SERVICE BULLETIN

Service Bulletin No.: DA20-79-05 Rev 4

Title: DA20 A1 - Oil Line Retrofit – F3 Engine

Figure 1

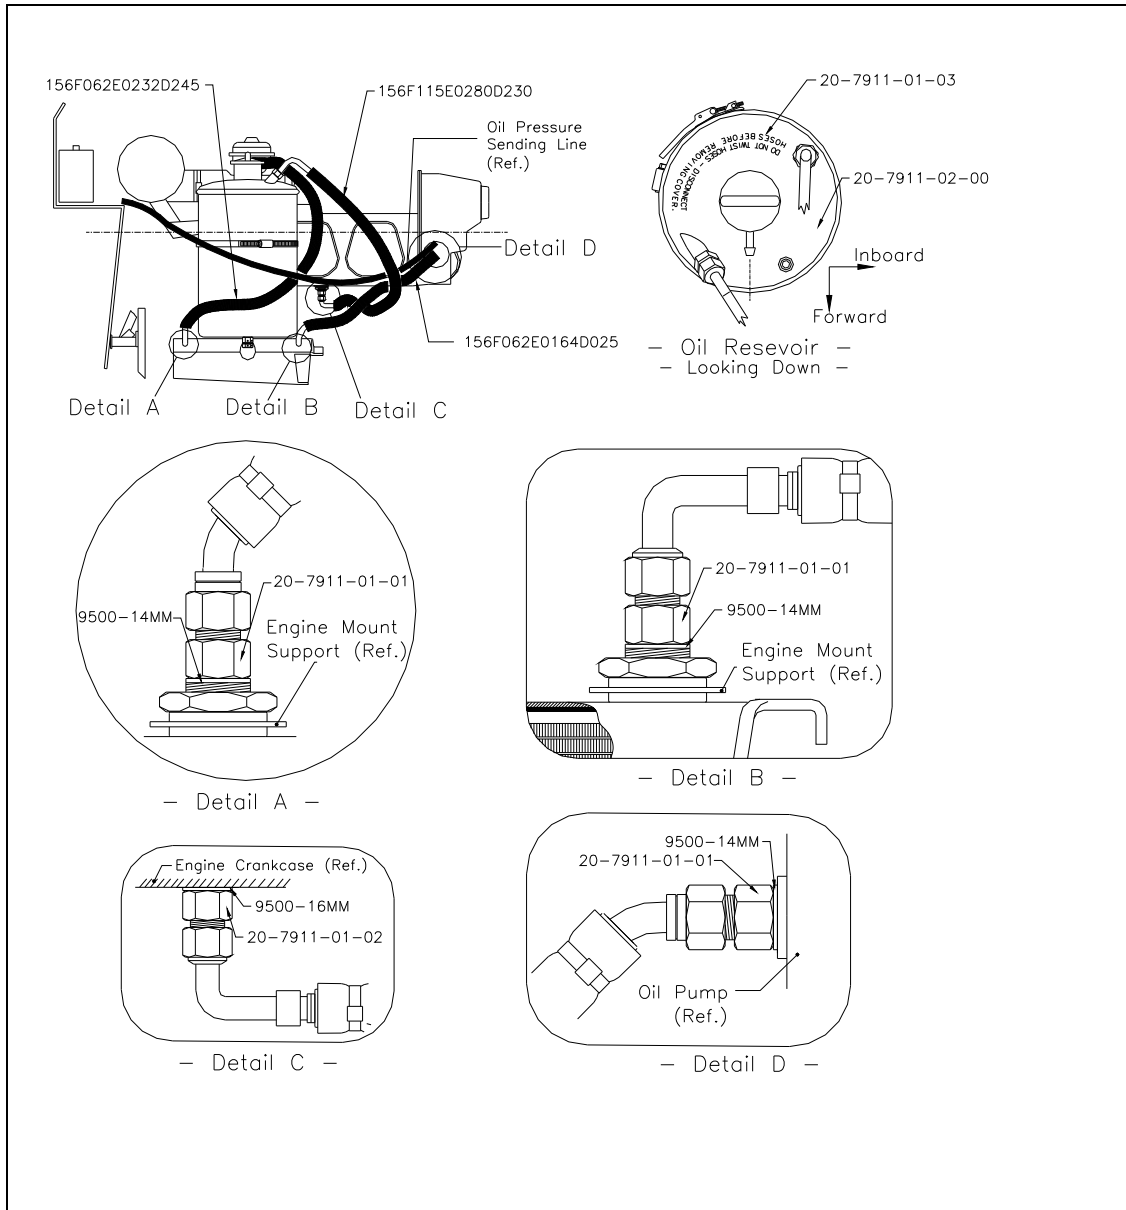
- 10.1** Remove upper and lower cowlings.
- 10.2** Remove and disassemble oil reservoir from aircraft in accordance with Rotax Maintenance Manual.
- 10.3** Assemble reservoir with supplied cover 20-7911-02-00 and O-ring 850-491 in reversed sequence of disassembly. Leave clamp loose to allow adjustment of orientation on installation.
- 10.4** Remove existing oil lines, i.e. sump to reservoir, reservoir to cooler, and cooler to pump, using a suitable container for oil.
- 10.5** Remove and discard the adapter fittings and sealing washers from oil cooler, engine sump and pump inlet.
- 10.6** Install remaining parts from kit as shown in Figure 1.
- 10.7** Torque adapters as follows:

Figure 2: Routing and securing oil lines (RH, looking inboard).

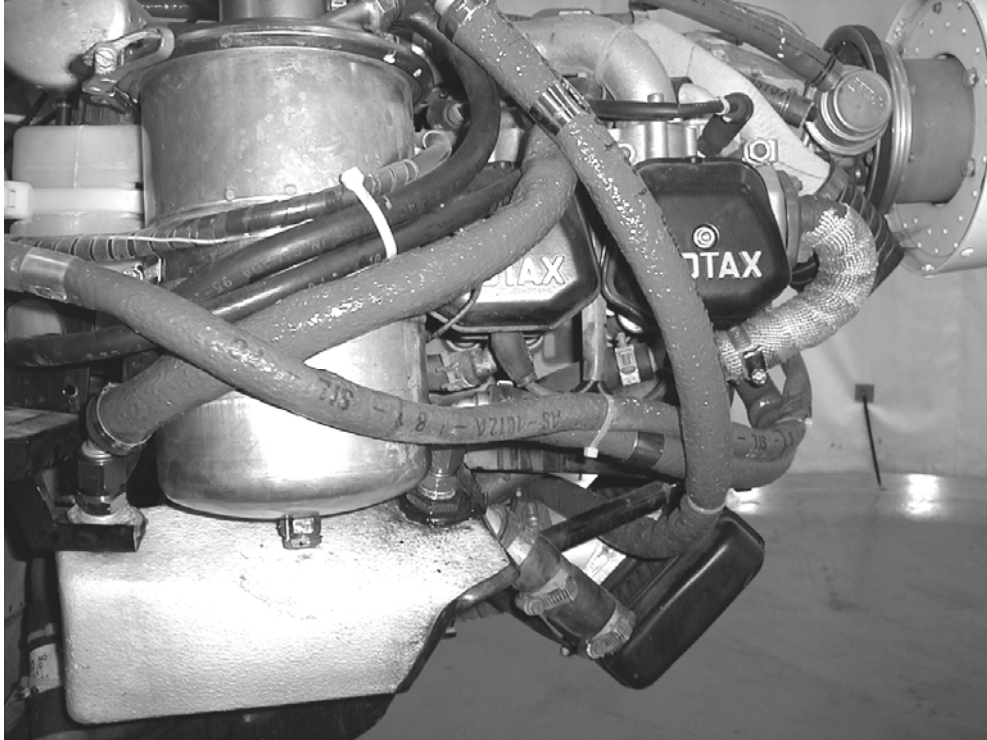
- 10.8** Route and secure oil lines as shown in Figures 2 and 3 using supplied tie-down straps, MS3367-5-9. ORIENT FITTINGS AND HOSES TO AVOID CONTACT WITH RADIATOR, ENGINE MOUNT AND CABIN HEATER SHROUD.
- 10.9** Ensure reservoir is in lowest position on engine mount. Do not allow reservoir to contact oil cooler shroud or upper surface of coolant overflow bottle.
- 10.10** Connect oil reservoir vent line.
